SAFETY INFORMATION NOTICE

AS350/H125/EC130 Crash Resistant Fuel System Retrofit Options and compliance with § 27.952

No. 3281-S-28

H125/B3e* approach to comply with 27.952

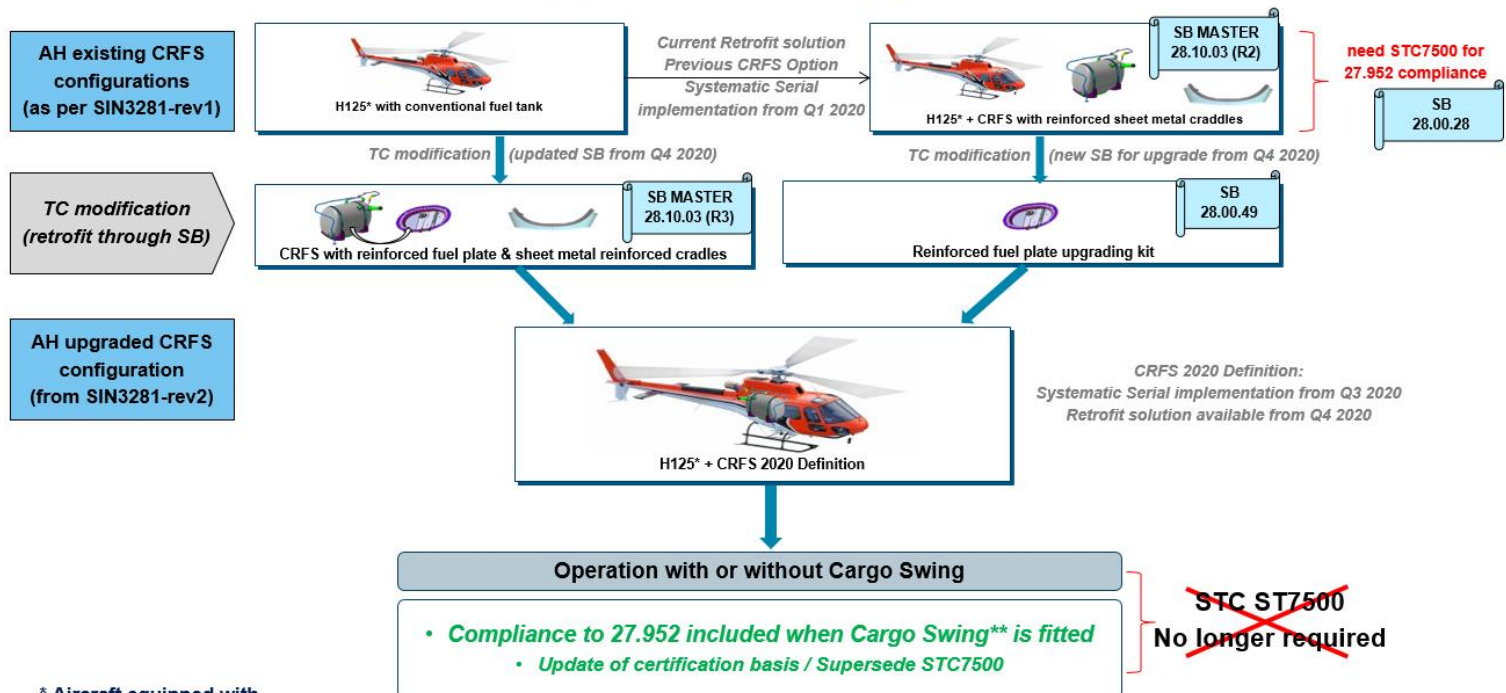
The available retrofit modifications that were needed to obtain a CS27.952 compliant CRFS excluding cargo swing installation (cargo swing operation remains possible but not compliant with CRFS requirements) are listed below:

- Aircraft equipped with the conventional AH fuel system can be upgraded with an Airbus Helicopters Rupture Resistant Fuel Tank (RRFT) through Service Bulletin No. AS350-28-10-03 (R2).
- Aircraft currently equipped with the AH RRFT can be upgraded to a CRFS through Service Bulletin No. AS350-28.00.28-STC to obtain compliance with § 27.952 as per EASA STC ST7500 (without underbelly installations).

Note: Swing operation remains possible by validating STC 7501 (compliance with §27.952 no longer covered).

The available retrofit modifications that are needed to obtain a CS27.952 compliant CRFS including cargo swing installation** (EASA certification obtained in December 2019) are listed below:

- Aircraft equipped with the conventional AH fuel system can be upgraded through Service Bulletin No. AS350-28-10-03 (R3 and further revisions) to obtain compliance with § 27.952 (including cargo swing installation**).
- Aircraft currently equipped with an RRFT or CRFS certified as per EASA STC ST7500 or ST7501 can be upgraded through Service Bulletin No. AS350-28.00.49 to obtain compliance with § 27.952 for cargo swing installation** (superseding STC7500/7501).

AS350B3* approach to comply with 27.952

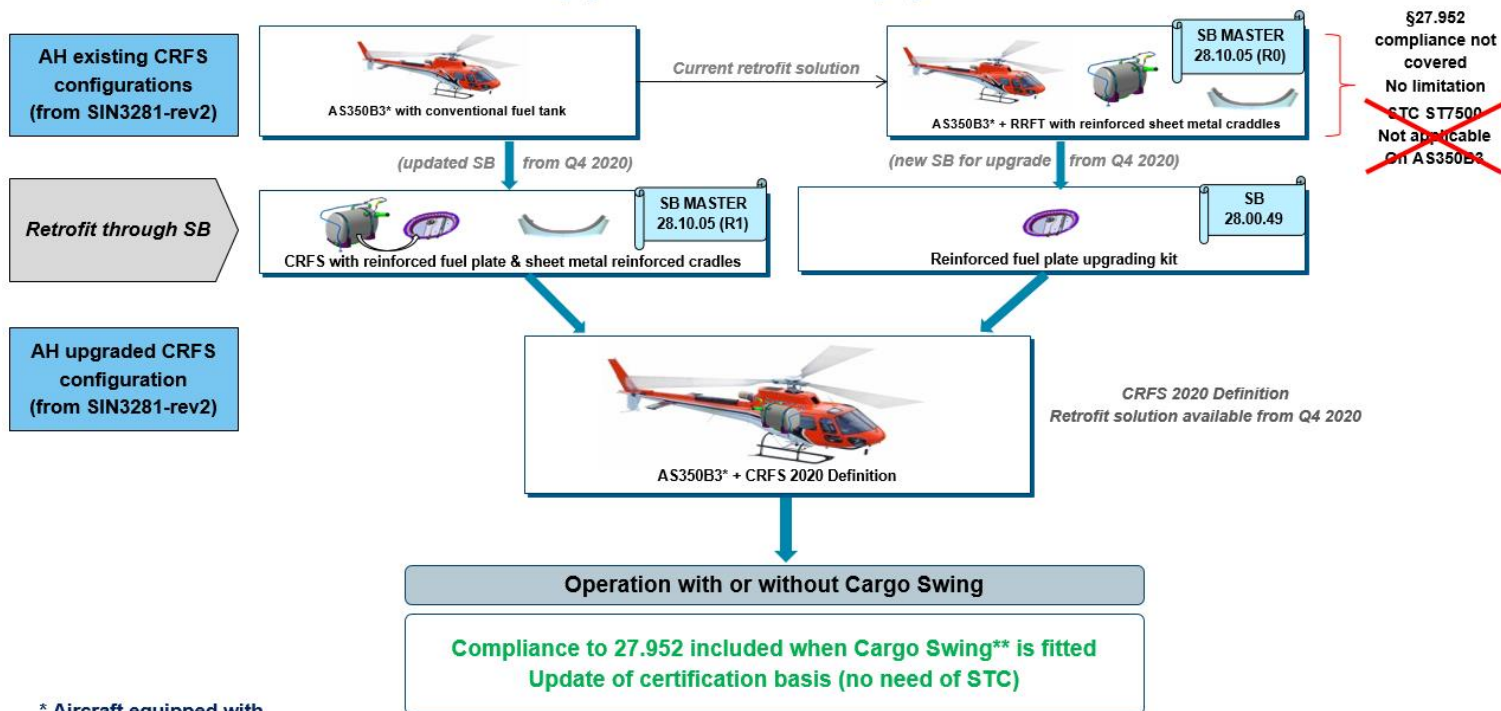
The available retrofit modification to install the Airbus RRFT on the AS350 B3 is listed below:

- Aircraft equipped with the conventional AH fuel system can be upgraded to a Rupture Resistant Fuel Tank (RRFT) through Service Bulletin No. AS350-28-10-05 (R0).
- Compliance with §27.952 is not covered (STC ST7500 not applicable to AS350 B3).
- It is possible to upgrade in a second step from the RRFT to a fully compliant CRFS (see below).

The available retrofit modifications that are needed to obtain a CS27.952 compliant CRFS including cargo swing installation** (EASA certification obtained in December 2019) are listed below:

- Aircraft equipped with a conventional AH fuel system can be upgraded through Service Bulletin No. AS350-28-10-05 (R1 and further revisions) to obtain full compliance with § 27.952 (including cargo swing installation**).
- Aircraft equipped with an AH RRFT can be upgraded through Service Bulletin No. AS350-28.00.49 to obtain full compliance with § 27.952 including cargo swing installation**.

EC130B4* approach to comply with 27.952

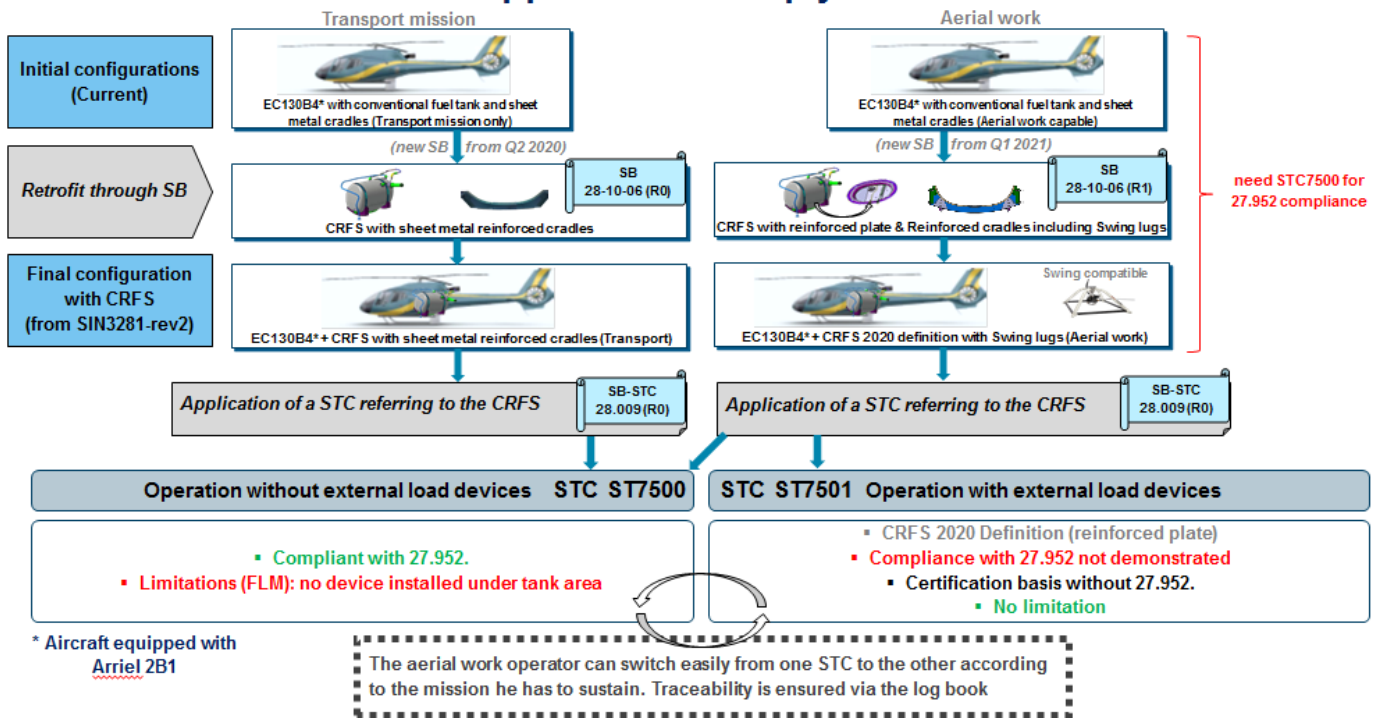
The available retrofit modifications to install the Airbus RRFT (without cargo CRFS swing capability) on the EC130-B4 and the method to achieve CS27.952 compliance with CRFS requirements excluding underbelly installations (EASA certification obtained in January 2020) are listed below:

- Aircraft equipped with a conventional AH fuel system can be upgraded to an AH RRFT through Service Bulletin No. EC130-28-10-06 (R0). This modification (available since Q2 2020) does not allow cargo swing operations as the related cradles do not have any provisions for the installation of the cargo swing.
- Aircraft equipped with the AH RRFT can be upgraded to a CRFS through Service Bulletin No. EC130-28-009-STC to obtain compliance with § 27.952 as per EASA STC ST7500 R1 (without underbelly installations).

The available retrofit modifications to install the Airbus RRFT (with cargo CRFS swing capability) and the method to achieve CS27.952 compliance with CRFS requirements excluding cargo swing installation (cargo swing operation remains possible but not compliant with CRFS requirements) (EASA certification obtained in January 2020) are listed below:

- Aircraft equipped with a conventional AH fuel system can be upgraded to the AH RRFT through Service Bulletin No. EC130-28-10-06 (R1 and further revisions). This modification (available from Q1 2021) includes cradles with provisions to install the cargo swing.
- Aircraft equipped with the AH RRFT can be upgraded through Service Bulletin No. EC130-28-009-STC to obtain compliance with § 27.952 as per EASA STC ST7500 (without underbelly installations).
